Item Name: Crosstube Turning Detail

DART AEROSPACE LTD		Work Order:	102001
Description: Crosstube Assembly (412 Low Narrow Fwd)		Part Number:	D412-664-145
Inspection Dwg: D412-664-145 Rev: D		Page 1 of 2

DRAWING NO. D412-664-145	TITLE CROSSTUBE ASS'Y (412 LOW-N FWD)	REV. D	DART AEROSPACE LTD ENGINEERING ORDER		D.E.O. NO. D412-664-145-D-1	SHEET NO. SHEET 1 OF 2	SCALE NTS
DRAWN 92	CHECKED SC	MFG. APPR. E	APPROVED WPD	DE APPR. H			
DATE 11.05.25	DATE 11.05.31	DATE 11.05.31	DATE 11/25/31	DATE 11.05.31

DRAWING NO. D412-664-145	TITLE CROSSTUBE ASS'Y (412 LOW IN FWD)	REV. D	DART AEROSPACE LTD ENGINEERING ORDER		D.E.O. NO. D412-664-145-D-3	SHEET NO. SHEET 1 OF 3	SCALE NTS
DRAWN 9	CHECKED	MFG. APPR.	APPROVED		DE APPR.		
DATE 12.08.21	DATE 2.06.30	DATE 2.08.30	DATE 12/8/30		DATE 12.08.30

**D412-664-145
ASSEMBLY DETAIL**

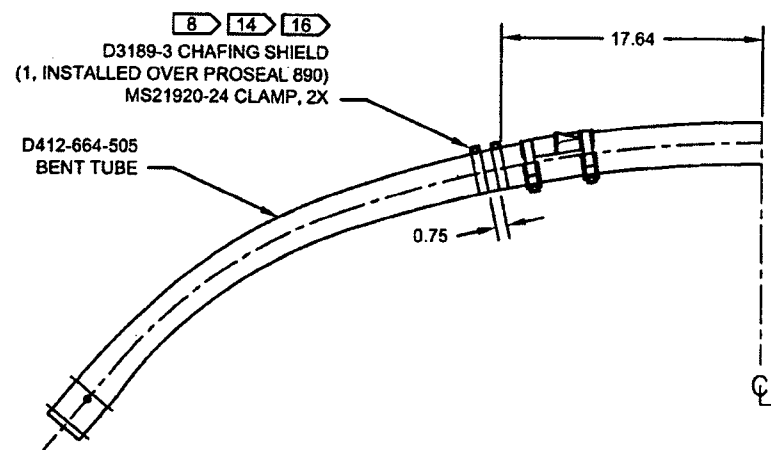
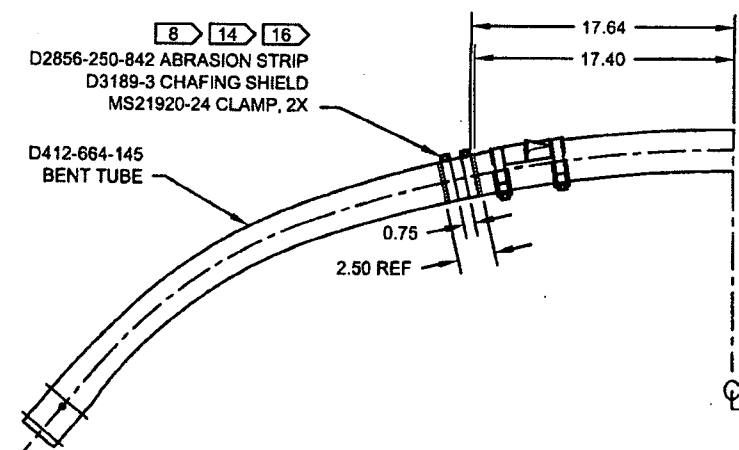
PURPOSE:

REMOVED ABRASION STRIP IN FAVOR OF A THIN LAYER OF PROSEAL 890.

IS:

WAS:

**D412-664-145
ASSEMBLY DETAIL**

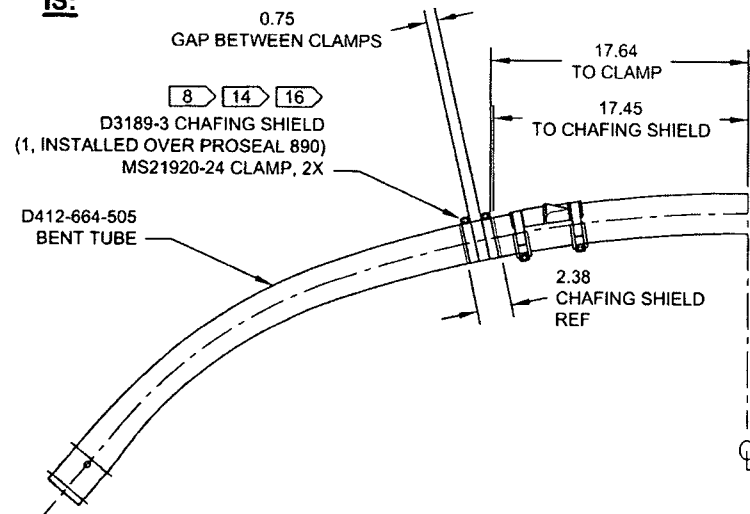
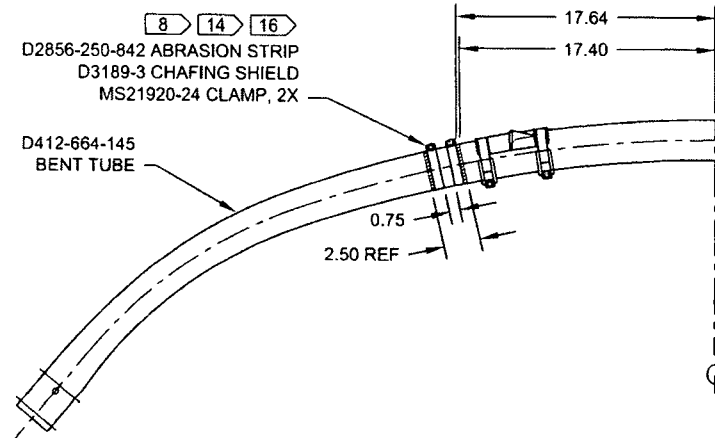
PURPOSE:

REMOVED ABRASION STRIP IN FAVOR OF A THIN LAYER OF PROSEAL 890. UPDATE INSTALLATION OF CHAFING SHIELDS AND REDUCE TORQUE TO 40-50 IN-LBS. THIS ENGINEERING ORDER SUPERCEDES DEO D412-664-145-D-1.

IS:

WAS:
